The District of North Vancouver REPORT TO COUNCIL

Case: PLN2025-00048

SUBJECT: Bylaw 8807: Revised Zoning Text Amendment for 2131-2171 Old Dollarton Road, 229-291 Riverside Drive & 2102-2128 Front Street ("Maplewood Gardens")

Proposed Level 2 Parkade Plan

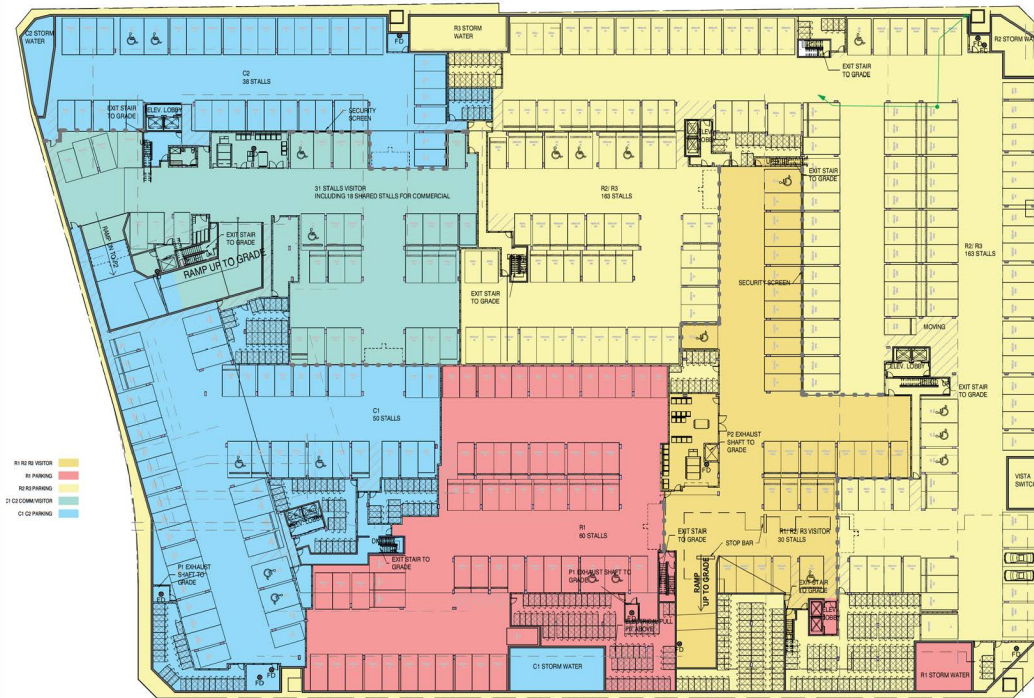
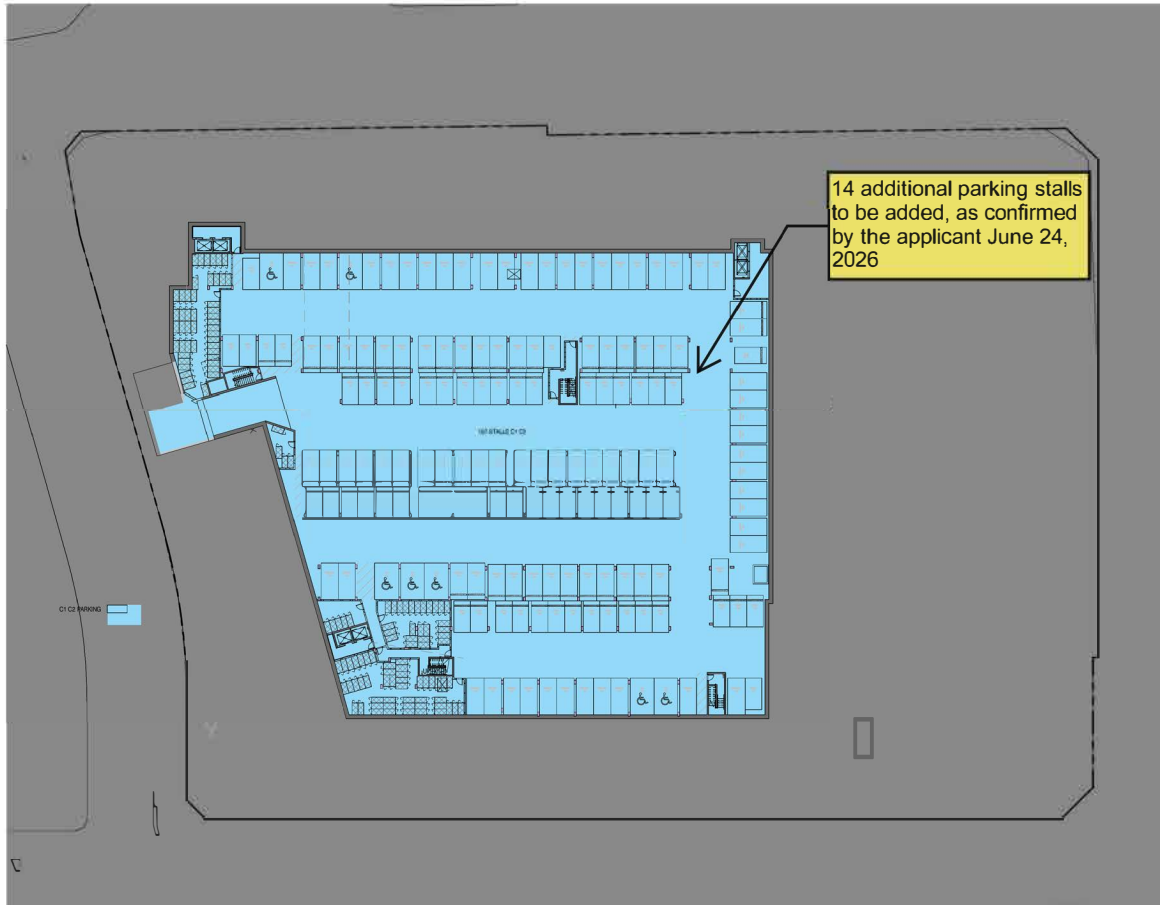
The primary change in the revised proposal is that the applicant has increased the vehicle parking for the remaining strata units, based on a 1.055/unit ratio rather than previously proposed 1/unit.

The parking rate for strata units was originally secured in the CD 152 zone at 1.1 stall/unit. The applicant previously proposed to reduce this rate to 1 stall/unit however the proposal was rejected by council. To address council concerns, the revised proposal increased this rate once more, to 1.055 stalls/ unit. This change equates to a total reduction of 12 stalls related to strata units, a 2.5% parking reduction overall.

Table 4 – Parking Requirements		
Building	Use	Required Parking Rate
C1 and C2	Residential and Live-work	1.055 stall / unit
	Commercial	1 stall / 45 m ²
	Visitor	0.1 stall / unit
	Accessible	4.5% of all required parking in C1 and C2
R1	Residential and Live-work	0.75 stall / unit
	Visitor	0.1 stall / unit
	Accessible	4.5% of all required parking in R1
R2 and R3	Residential	0.75 stall / unit
	Visitor	0.1 stall / unit
	Accessible	4.5% of all required parking in R2 and R3

Proposed Roof Plan

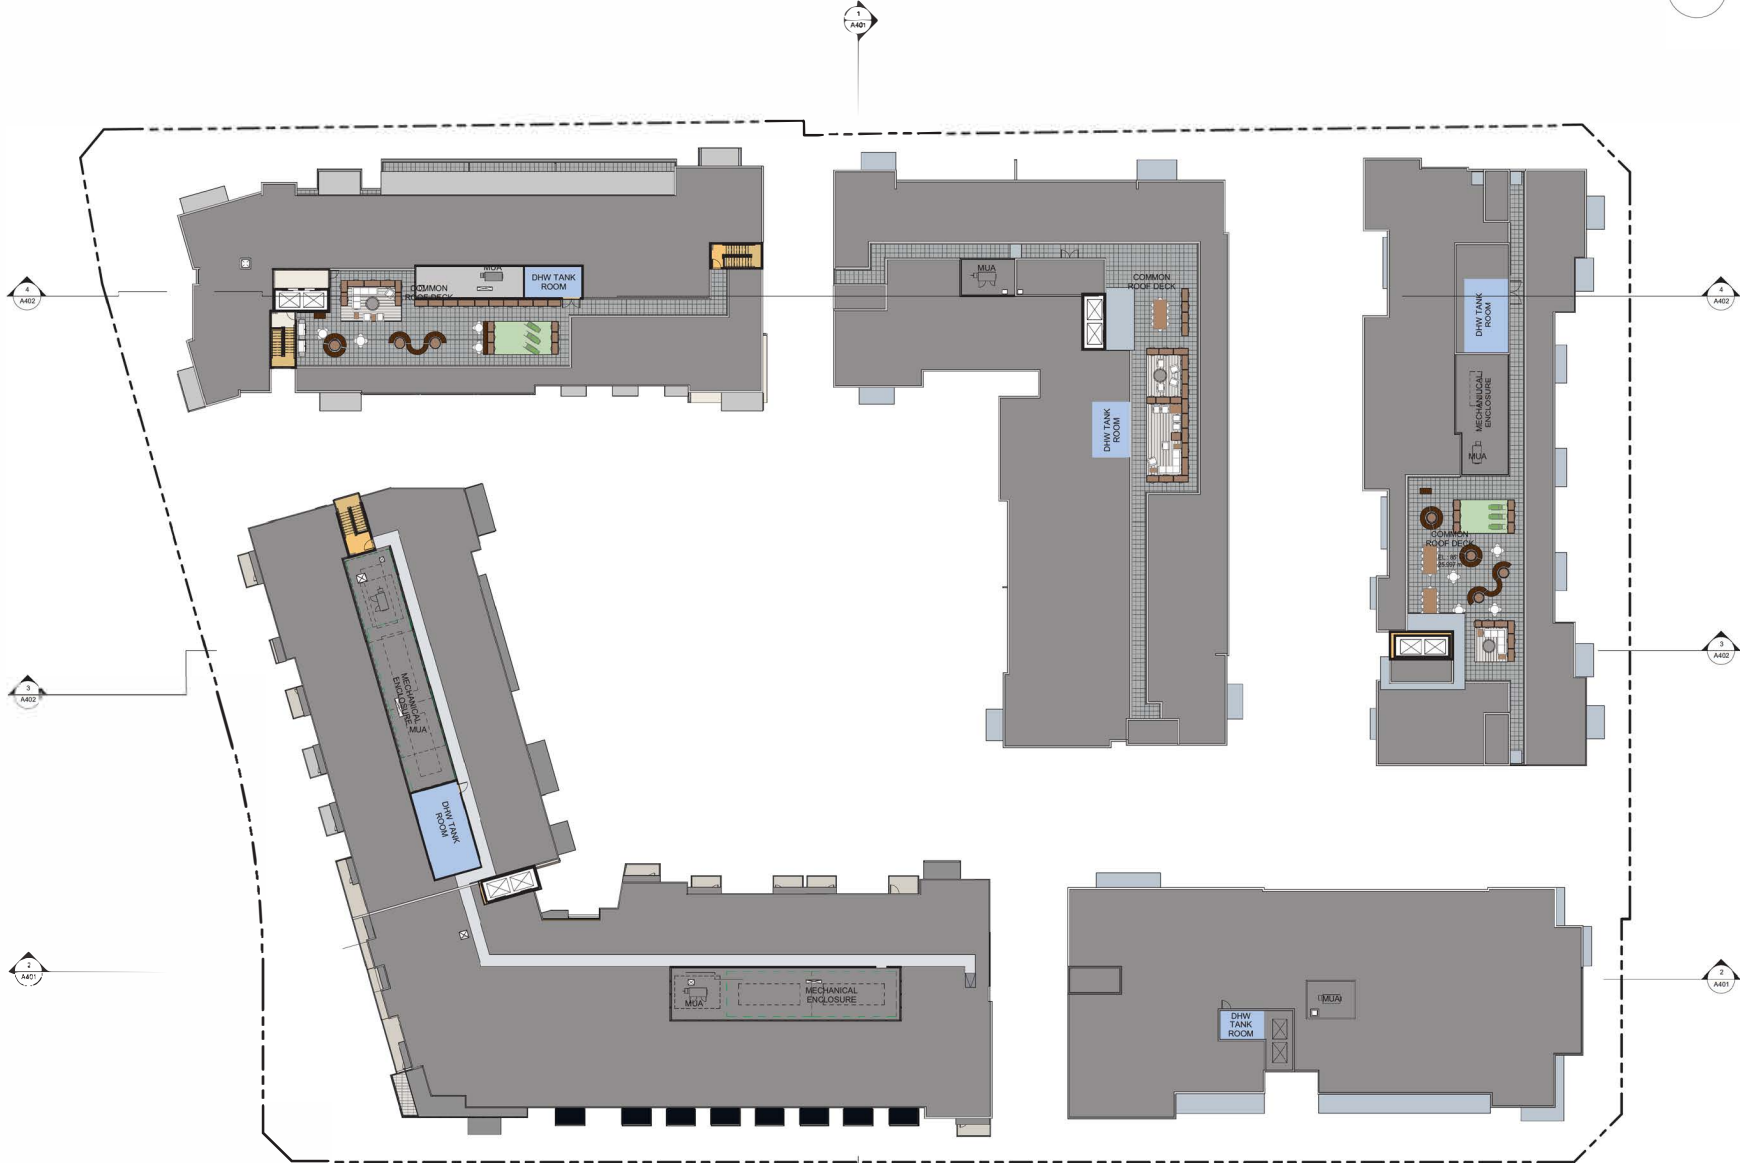
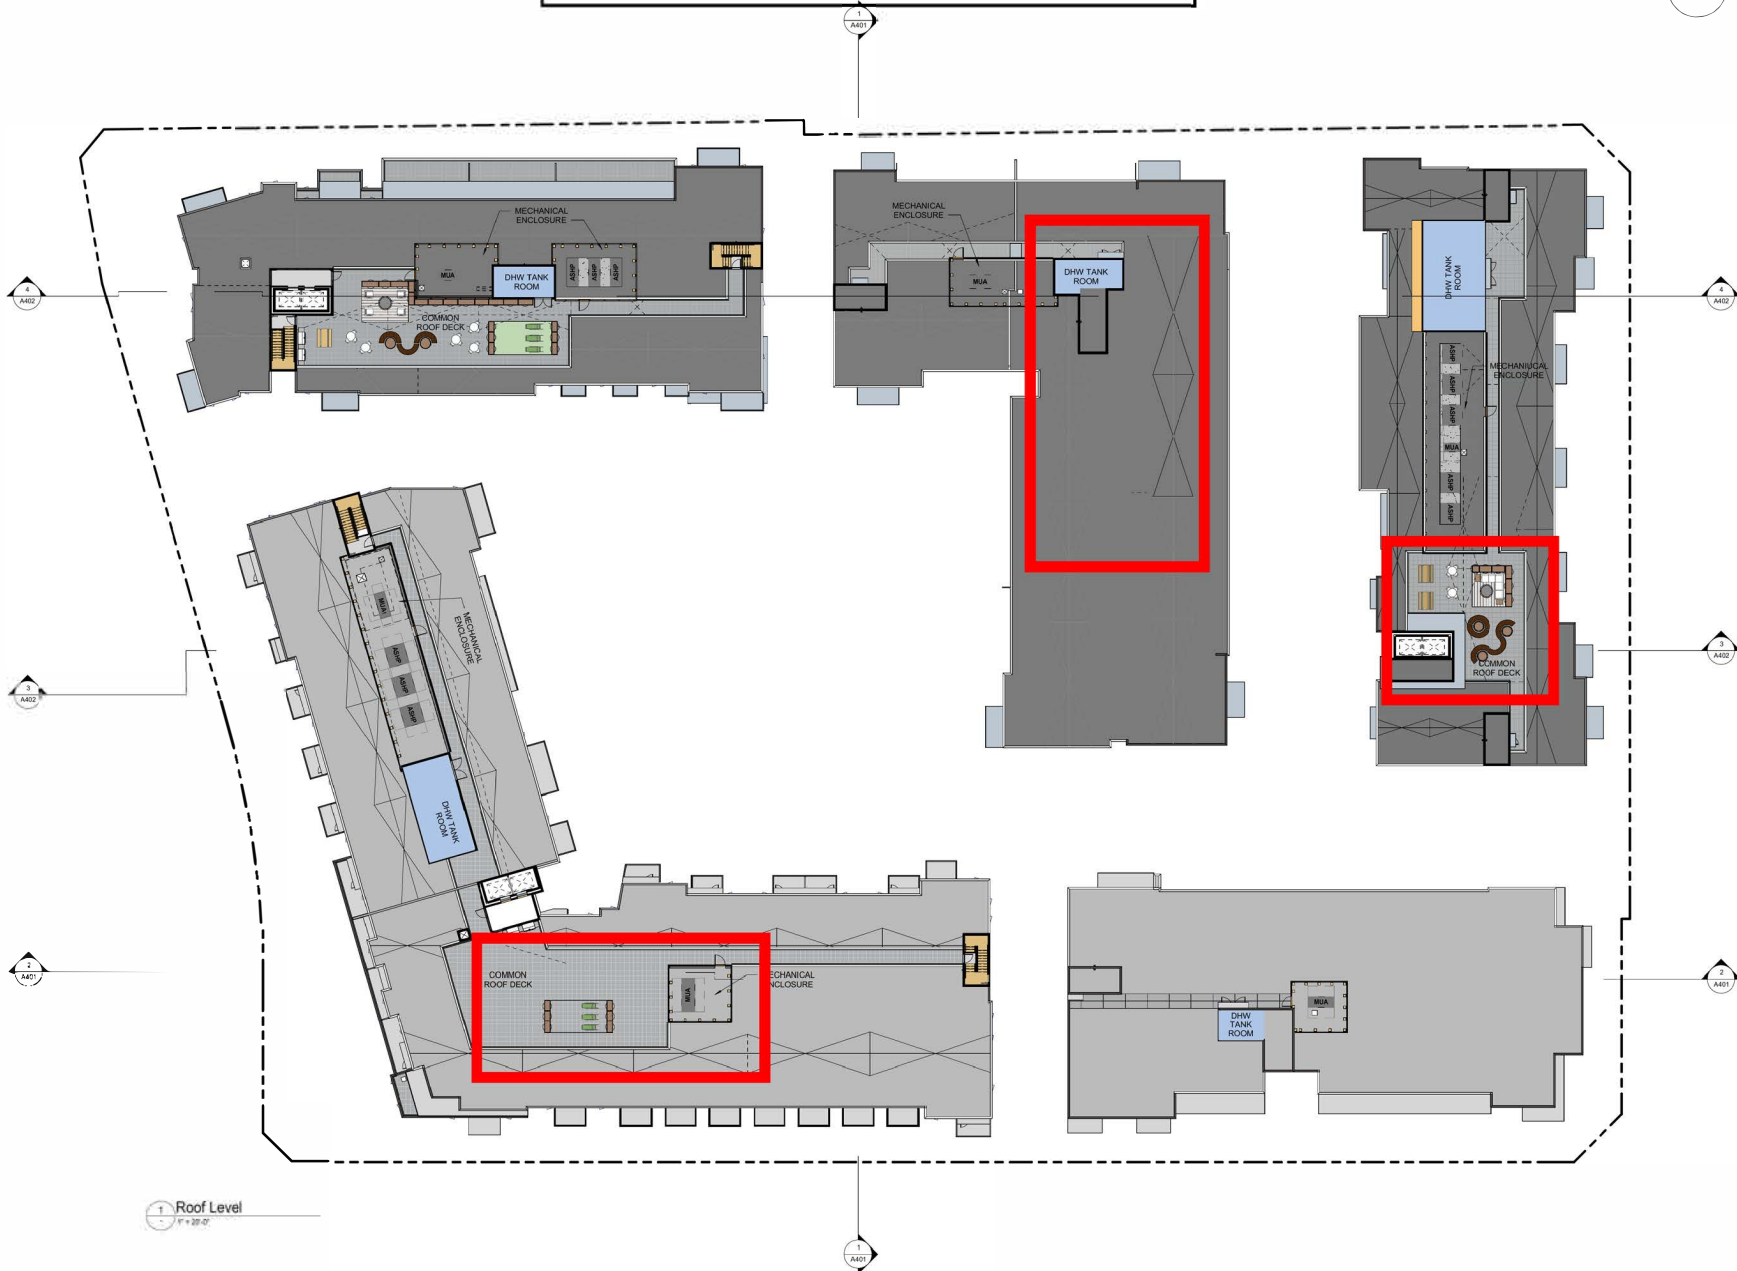
- Conversion of 121 units from strata to 101 rental and 20 below market rental;
- Revised vehicle parking for converted rental units in accordance with CD 152 zone;
- An adjustment to building height exception for building C1 to allow for mechanical and electrical rooms on rooftop; and
- Adjustments to the excluded floor area for amenity space to accommodate revised amenity locations.

Table 3 – Building Height			
Building	Maximum Building Height	Maximum Height Exceptions	Maximum Storeys
Building C1	21m (68.75 ft.)	5 m (16.25 ft.)	6
Building C2	20.8m (68.2 ft.)	5 m (16.25 ft.)	6
Building R3	19.8m (65 ft.)	5 m (16.25 ft.)	6
Building R2	19.8m (65 ft.)	5 m (16.25 ft.)	6
Building R1	19.8m (65 ft.)	2.7 m (9 ft.)	6
